Contract #: 04-0120F4Cty: SF/ALA Rte: 80 PM: 13.2/13.9File #: 69.25B**QUALITY ASSURANCE -- NON-CONFORMANCE REPORT****Location:** Changxing Island, Shanghai P.R. China**Report No:** NCR-000943**Prime Contractor:** American Bridge/Fluor Enterprises, a JV**Date:** 13-Dec-2010**Submitting Contractor:** Zhenhua Port Machinery Company, Ltd (ZPMC), Changxing Island**NCR #:** ZPMC-0902**Type of problem:**

Reference Description: 2 Transverse Cracks located at Tower Facade Connection Plate**Description of Non-Conformance:**

Job Name: SAS Superstructure
Document No: 05.03.06-000898

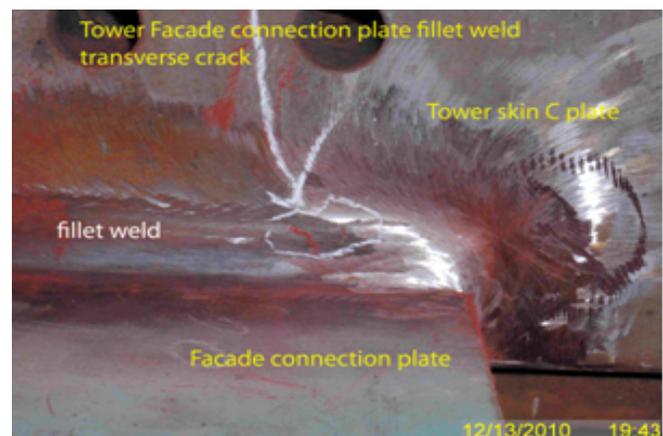
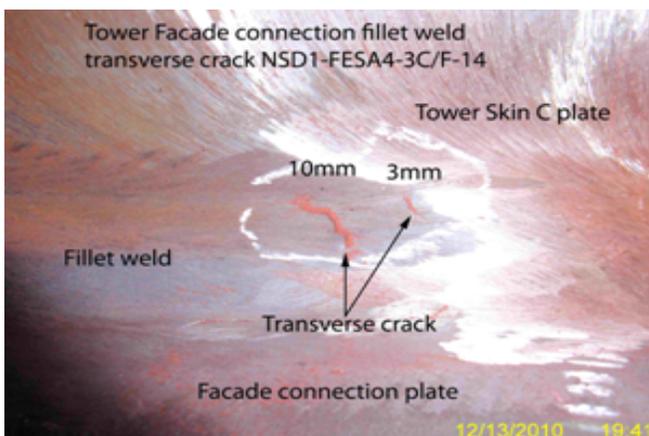
During the Quality Assurance Magnetic particle Testing (MT) review of welds located on NSD1-FESA4-3C/F, this Quality Assurance Inspector (QA) discovered the following issues:

- 2 Transverse cracks measuring approximately 3mm and 10mm.
- The weld is identified as: NSD1-FESA4-3C/F-14
- The Y location is approximately 25mm and 35mm, respectively from the right end of the weld.
- The Weld is a fillet weld joining the façade connection plate to north tower skin C.
- The weld is not SPCM.
- The member is located in Bay # 10

The Notice of Witness Inspection Number (NWIT) is 7766. The indication is within the area that has been previously tested and accepted by ZPMC Quality Control (QC) personnel. As per the contract documents, ZPMC's QC personnel are required to perform 10% MT inspection of this weld.

Reference Description: 2 Transverse Cracks located at Tower Facade Connection Plate

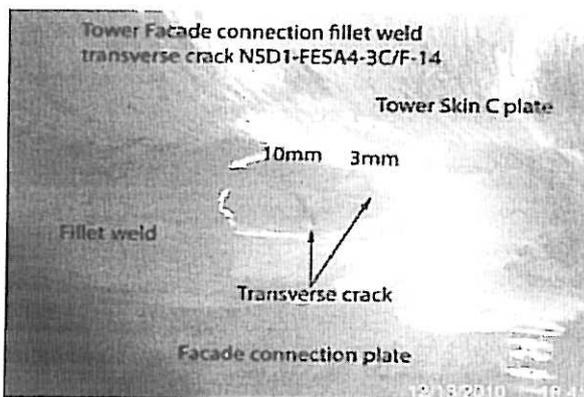
During the Quality Assurance Magnetic particle Testing (MT) review of welds located on NSD1-FESA4-3C/F, this Quality Assurance Inspector (QA) discovered the following issues:

- 2 Transverse cracks measuring approximately 3mm and 10mm.
- The weld is identified as: NSD1-FESA4-3C/F-14
- The Y location is approximately 25mm and 35mm, respectively from the right end of the weld.
- The Weld is a fillet weld joining the facade connection plate to north tower skin C.
- The weld is not SPCM.
- The member is located in Bay # 10

The Notice of Witness Inspection Number (NWIT) is 7766. The indication is within the area that has been previously tested and accepted by ZPMC Quality Control (QC) personnel. As per the contract documents, ZPMC's QC personnel are required to perform 10% MT inspection of this weld.

Draft of Welding Discontinuity:

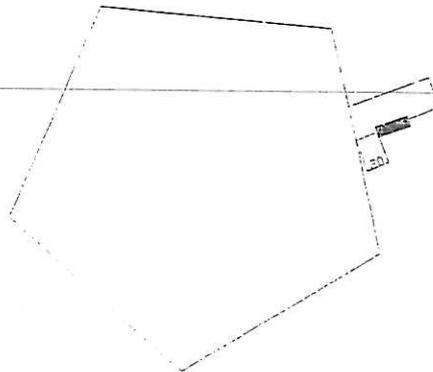
线性缺陷
Linear indication

List weld No.(焊缝编号) : NSD1-FESA4-3C/F-14

1. 火焰加热时, 水汽没有完全的去掉或者这个区域预热不够;
1. Moisture wasn't completely removed during drying operation (preheating) or the area wasn't preheated sufficiently.

1. QC and a Lead CWI shall be present, direct and supervise all grinding and welding operations during this repair to ensure the repair is per the disposition requirements

2. QC and a Lead CWI shall have an approved copy of the CWR in hand prior to the repair.
3. Remove paint $\geq 25\text{mm}$ in all direction of HAZ prior to MT.

4. Clean the excavation area of all loose debris including MT powder. Preheat to 65° C before removing cracks by grinding, repair area shall extend a minimum of 50mm beyond each end of single crack repairs, (and 50mm beyond the outermost cracks for multiple crack repairs).

5. If base metal is damaged by grinding, the damaged area shall be ground clean prior to performing weld repair. If gap $> 5\text{mm}$ is found during or after grinding, comply with the notification on changing fillet weld to CJP which is submitted to Engineer's review and approval form. Prior to continuing with Repair work.
